**STATE OF NEW MEXICO**  
**Before the**  
**SECRETARY OF THE ENVIRONMENT**

*In the matter of the* )  
RENEWAL AND MODIFICATION OF )      GWB No. 09-35(P)  
BARRICK GOLD *dba* HOMESTAKE MINING )  
COMPANY DISCHARGE PERMIT, DP-725 )      March 8, 2010

**BLUEWATER VALLEY DOWNSTREAM ALLIANCE**  
**REQUESTED FINDINGS OF FACT, CONCLUSIONS OF LAW, RELIEF**  
**AND PROPOSED ORDER**

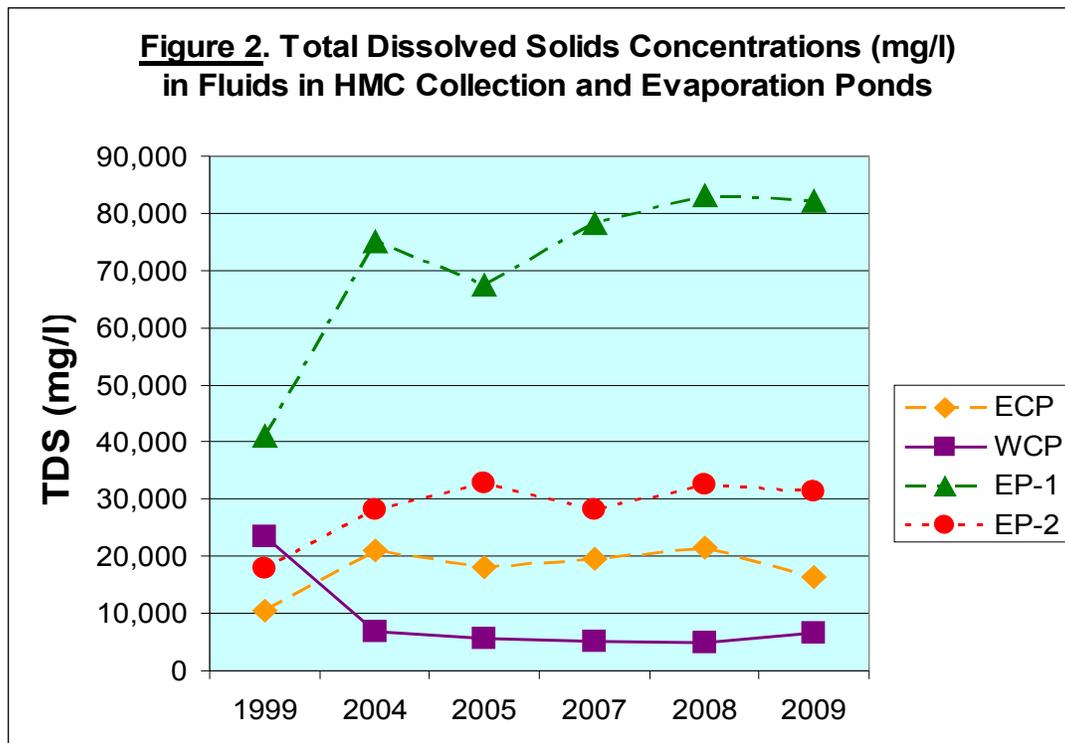
55. High-TDS water is also present in ECP and EP2, as shown in **Table 1** (above) and **Figure 2**. **Figure 2** (next page) further suggests that TDS concentrations increased substantially between 1999 and 2004 in ECP, EP1 and EP2. Conversely, a substantial decrease in TDS concentrations was observed in fluids in WCP between 1999 and 2004.

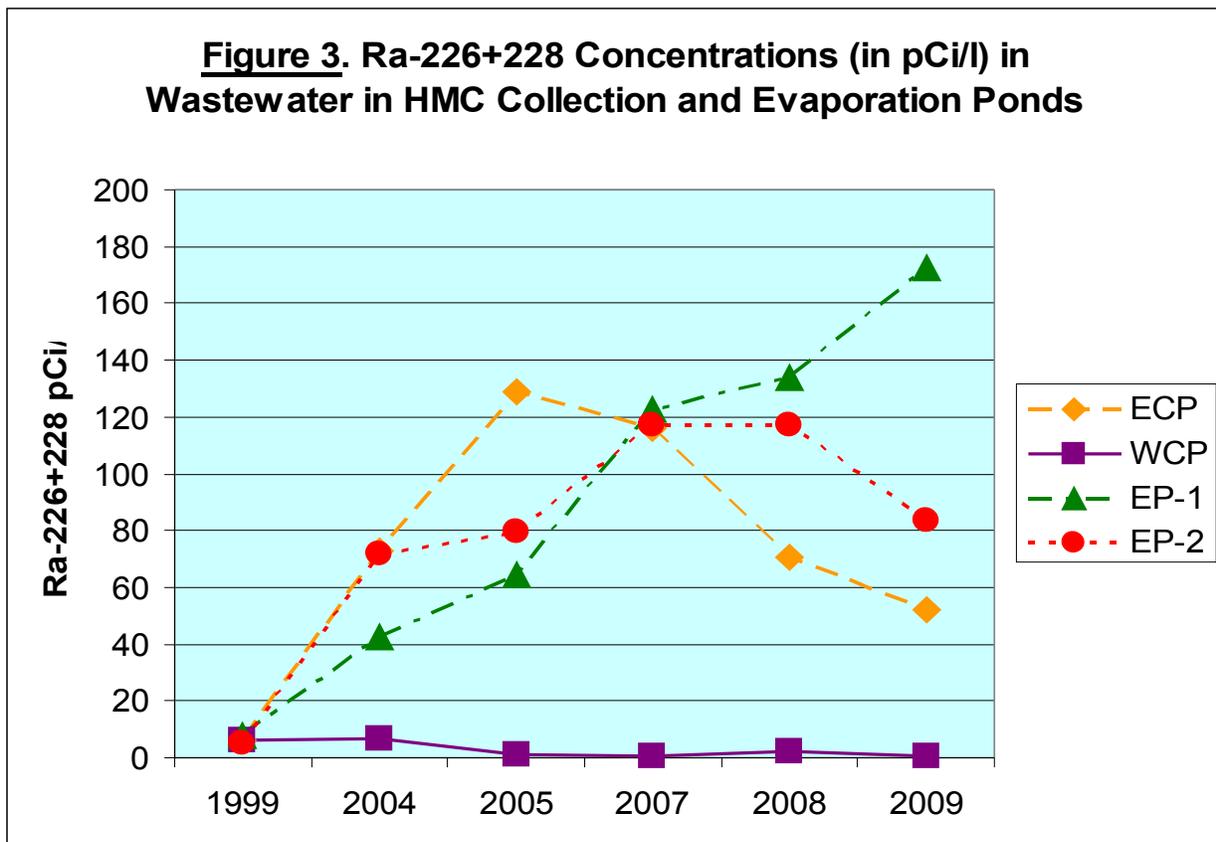
68. As shown in **Figure 3** (below), average annual total radium (i.e., Ra-226+Ra-228) concentrations increased from single-digit levels in 1999 (average concentration of 5.4 picoCuries per liter [pCi/l] for fluids in all four ponds) to about 100 pCi/l for fluids in EP1, EP2 and ECP combined in 2009. Total radium levels have increased in fluids in EP1 in each of the six years represented in **Figure 3**. *Id.*

71. The high radium concentrations in the effluent stored in the collection and evaporation ponds suggest that radium levels are also likely to be elevated in the sediments accumulating in these ponds. *Id.* (emphasis added).
